Project	IEEE 802.16 Broadband Wireless Access Working Group < http://ieee802.org/16 >	
Title	MS handover to target MR-BS with transparent RS	
Date	2007-04-30	
Submitted		
Source(s)	<p>Kanchei (Ken) Loa, Yi-Hsueh Tsai, Voice: +886-2-2739-9616 Chih-Chiang Hsieh, Yung-Ting Lee, loa@iii.org.tw Hua-Chiang Yin, Shiann-Tsong Sheu, Frank C.D. Tsai, Youn-Tai Lee, Heng-Iang Hsu Institute for Information Industry 8F., No. 218, Sec. 2, Dunhua S. Rd., Taipei City, Taiwan.</p> <p>[add co-authors here]</p>	
Re:	IEEE 802.16j-07/013: "Call for Technical Comments Regarding IEEE Project 802.16j"	
Abstract	This contribution proposes procedures for network topology advertisement in MR system	
Purpose	Text proposal for 802.16j Baseline Document	
Notice	<p>This document has been prepared to assist IEEE 802.16. It is offered as a basis for discussion and is not binding on the contributing individual(s) or organization(s). The material in this document is subject to change in form and content after further study. The contributor(s) reserve(s) the right to add, amend or withdraw material contained herein.</p>

MS handover to target MR-BS with transparent RS

Figure xxx –Network topology advertisement in transparent RS system

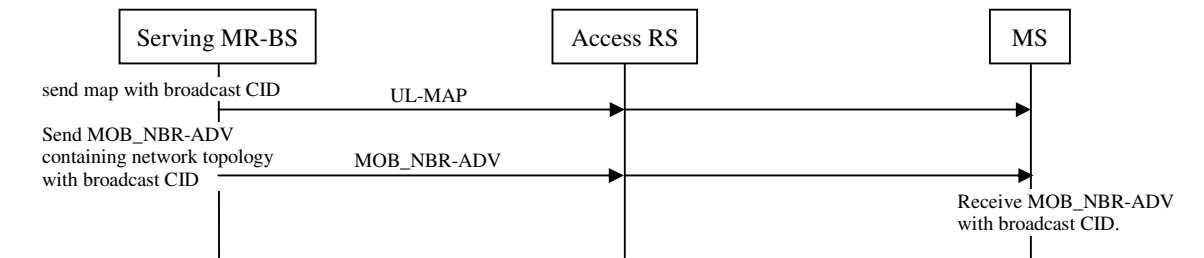
The MR-BS and the RS shall broadcast information about the infrastructure stations that are present in the network using the MOB_NBR-ADV message defined in 6.3.2.3.47. The MR-BS and the RS may obtain the information to be included in the MOB_NBR-ADV message over the backbone network or over the relay links. Each non-transparent RS can broadcast a different MOB_NBR-ADV message that is suitable for its service area. For transparent RS, the MOB_NBR-ADV message shall be broadcasted by the MR-BS depicted in Figure xxx.

Figure yyy – Network advertisement in non-transparent RS system with centralized scheduling

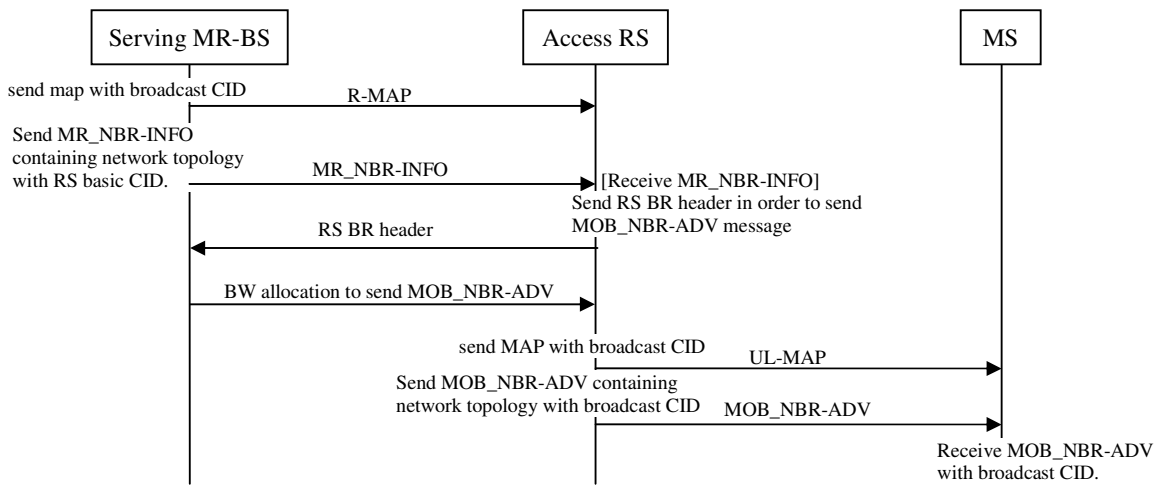
- (a) An RS can broadcast the MOB_NBR-ADV message without modifying the neighbor list of the MR_NBR-INFO message, received from the MR-BS.
- (b) An RS can further customize and compose a MOB_NBR-ADV message that is suitable for its service area by utilizing the information present in the MR_NBR-INFO messages received from the MR-BS.
- (c) Under centralized scheduling, as shown in Figure yyy, the RS shall request bandwidth on the access link to broadcast MOB_NBR-ADV.
- (d) Under distributed scheduling, as shown in Figure zzz, the RS shall autonomously broadcast MOB_NBR-ADV on the access link.
